SS 716 - WST 2021 49X Exterior Sun Visor Loose

WST 49X vehicles built with an exterior sun visor prior to 6/14/2021.

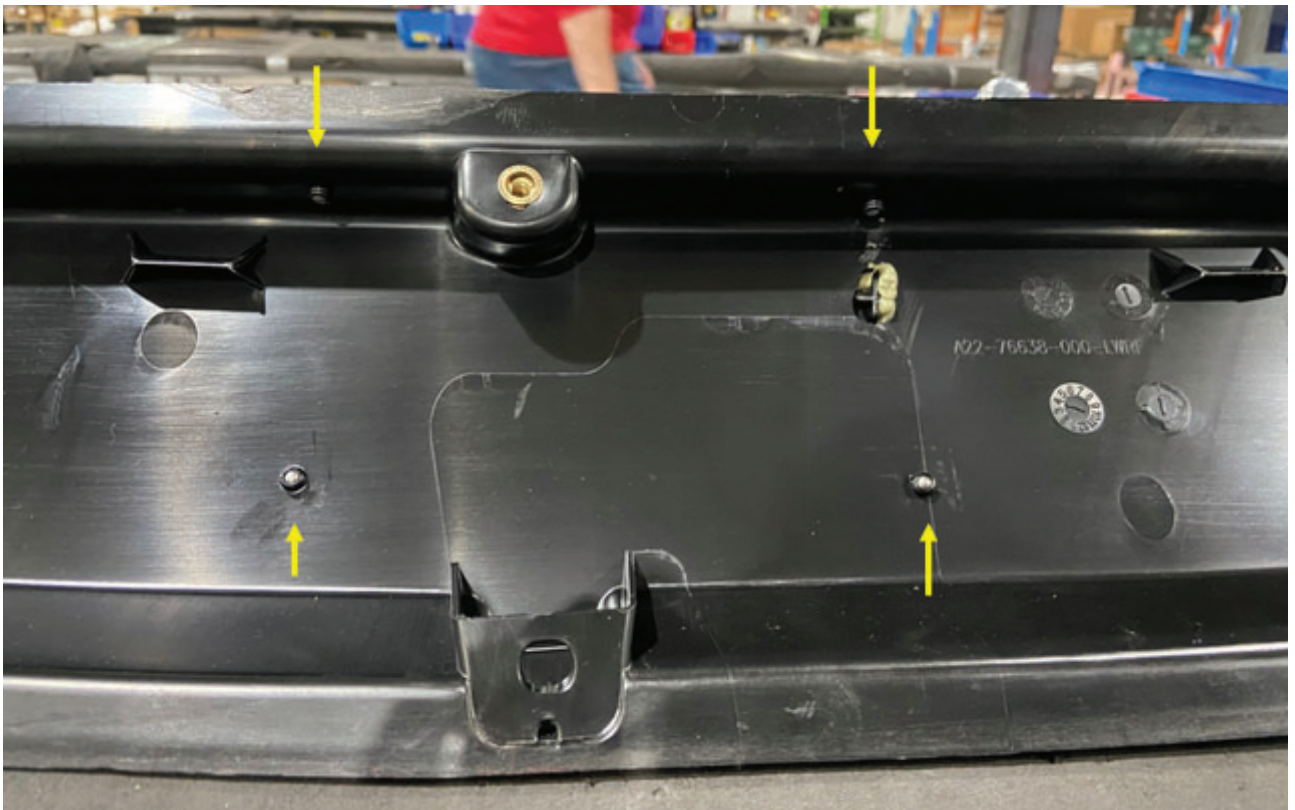
Sun visor is loose, audible noise coming from the roof.

Leg support of sun visor may debond from visor installation.

Add pop rivets and re-apply bonding adhesive to re-attach sun visor per instructions below:

- Remove stainless steel panel from sun visor mount.
- Drill .199 dia hole (4X) in approximate locations shown in photos below through both mounting leg and visor assembly while still installed to roof cap to ensure proper location when remounted.
- Remove sun visor and mounting leg from roof of cab.
- Remove existing glue material from both mounting leg and sun visor mount.
- Apply adhesive bond 48-25123-015 (Lord Maxlok MX/T18 or equivalent) per spec 49-00093-001 between mounting leg and visor mount while installing 4 pop rivets as shown in photos below (part number 23-09990-106 RVT-BL 3/16X.437,DOME HD,BLK)
- Re-attach visor mount to roof cap per proper torq procedures. Re-attach stainless steel panel per proper torq procedures.
